Terex Utilities**PRODUCT NOTICE****PN718****DATE:** 5/11/2023**REVISED:****TO:** Owners, Users, Dealers, and Installers**MODELS AFFECTED:** Optima HR55 & Optima TC55 Aerials**SUBJECT:** Pedestal Grounding Cable**Issue:**

Figure 1. Area of Pedestal to Inspect for Grounding Cable

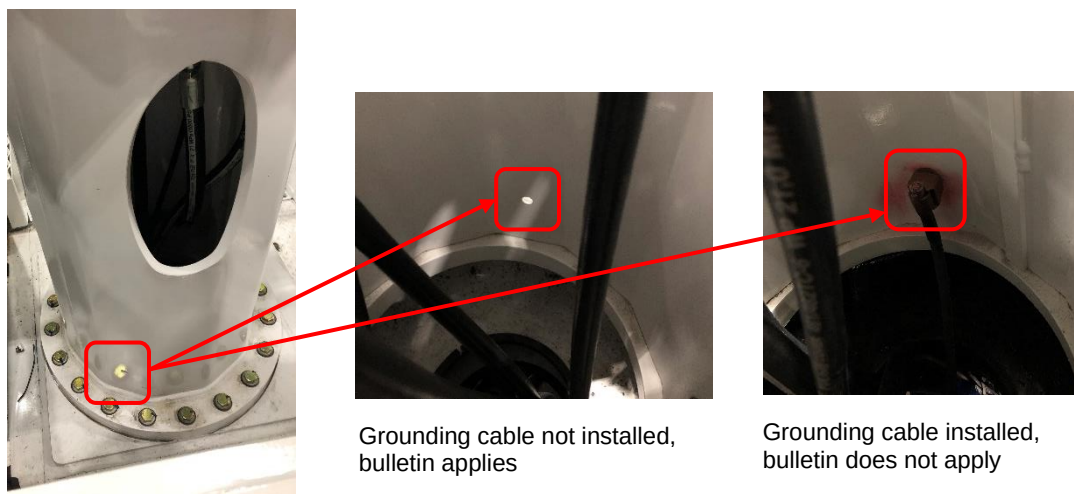
Terex model Optima HR55 & Optima TC55 mounted on International eMV chassis, produced from June 2022 through January 2023, may not have a grounding cable from the pedestal to the chassis frame. When the chassis grounding option is ordered, a grounding cable from the pedestal to the chassis frame is required to ensure low electrical resistance between the pedestal and chassis frame when the pedestal attaches to the subframe via bolts.

1. Inspect the pedestal side wall to determine if a grounding cable is installed, using Figure 1 for reference.
 - a. If the grounding cable is installed, this bulletin does not apply.
 - b. If the grounding cable is not installed, this bulletin applies. The unit may continue to be used following the continued use instructions detailed in this bulletin.

Terex will provide Field Service Kit Z1678, parts and one (1) hours labor, at no cost to the customer for a period of six (6) months from the release date of this bulletin. The Field Service Kit Z1678, which contains a grounding cable and attachment hardware, will be provided to the nearest Terex Utilities dealer or Field Service Technician for installation on your machine.
